PECOS DISTRICT CONDITIONS OF APPROVAL

OPERATOR'S NAME:	Devon Energy Production Company LP
LEASE NO.:	NM-0544986
WELL NAME & NO.:	Aldabra 25 Federal #3H
SURFACE HOLE FOOTAGE:	200' FSL & 2260' FWL
BOTTOM HOLE FOOTAGE:	330' FNL & 1650' FWL
LOCATION:	Section 25, T. 23 S., R. 31 E., NMPM
COUNTY:	Eddy County, New Mexico

Figure 1 – Cross Sections and Plans For Typical Road Sections

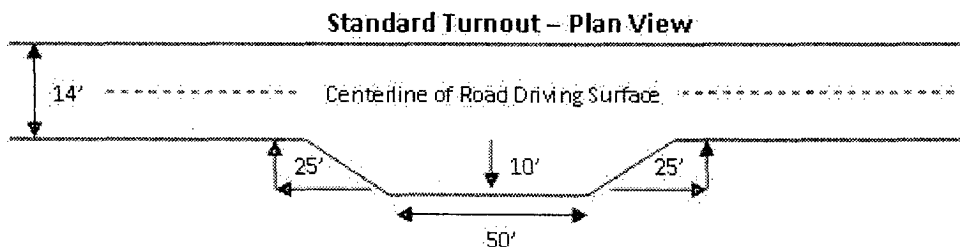
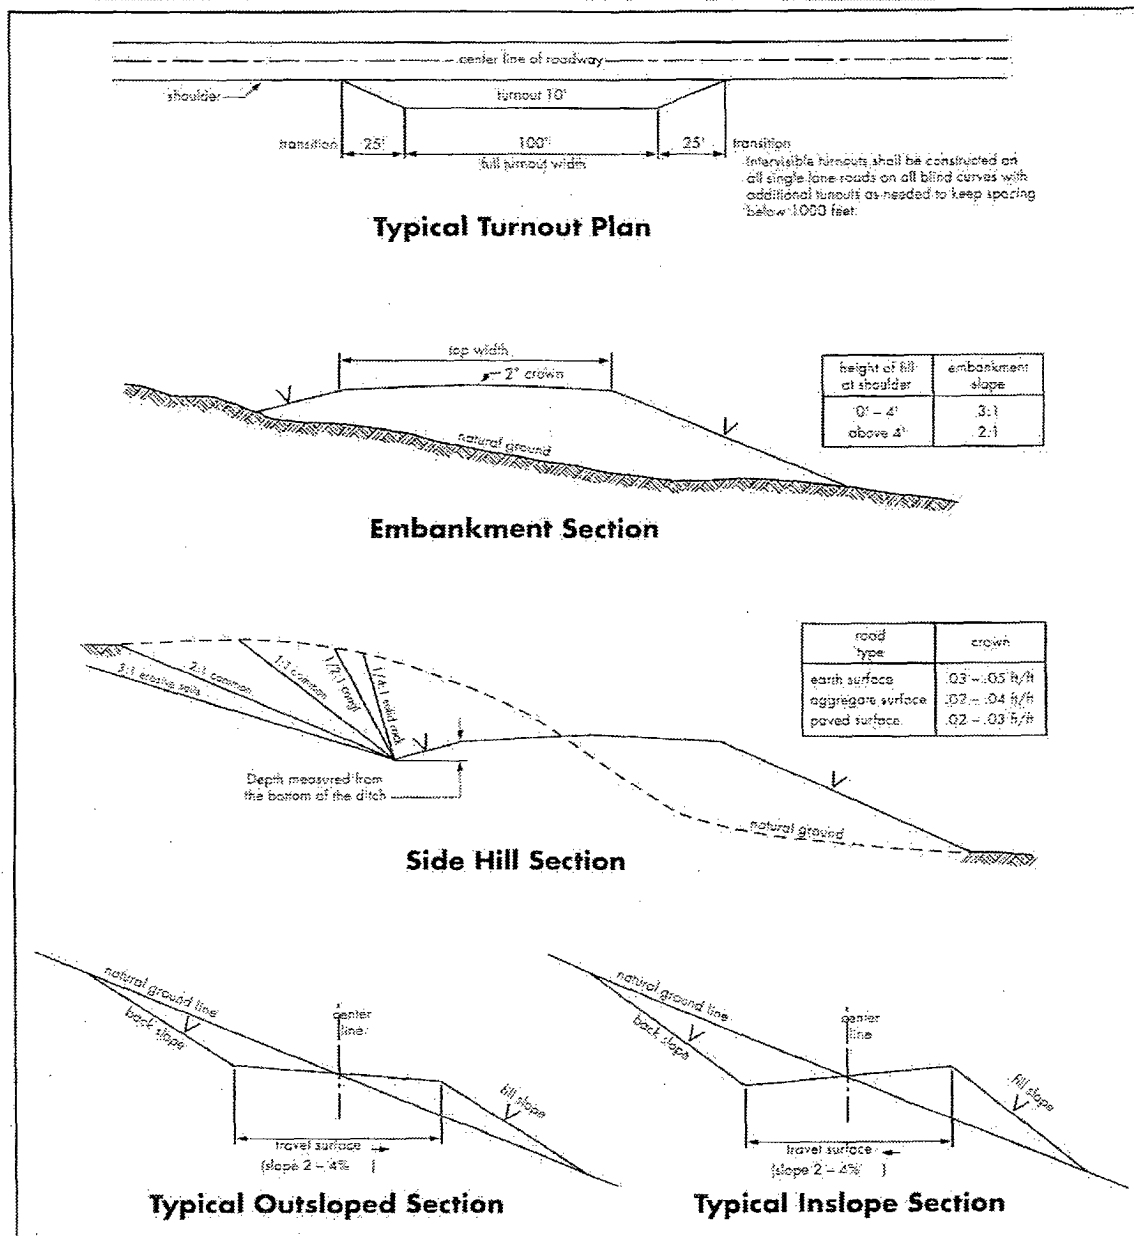
Crowning shall be done on the access road driving surface. The road crown shall have a grade of approximately 2% (i.e., a 1" crown on a 14' wide road). The road shall conform to Figure 1; cross section and plans for typical road construction.

Cross Section of a Typical Lead-off Ditch

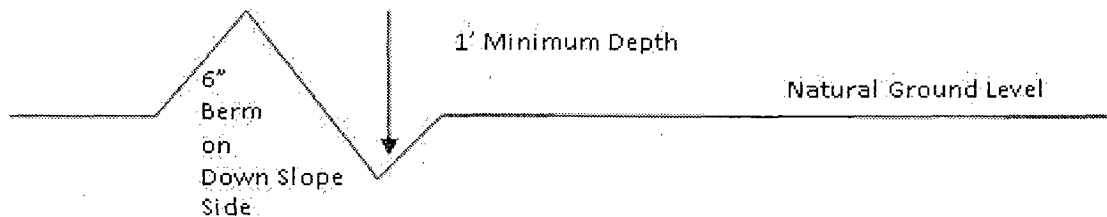
A typical lead-off ditch has a minimum depth of 1 foot below and a berm of 6 inches above natural ground level. The berm shall be on the down-slope side of the lead-off ditch.

All lead-off ditches shall be graded to drain water with a 1 percent minimum to 3 percent maximum ditch slope. The spacing interval are variable for lead-off ditches and shall be determined according to the formula for spacing intervals of lead-off ditches, but may be amended depending upon existing soil types and centerline road slope (in %);
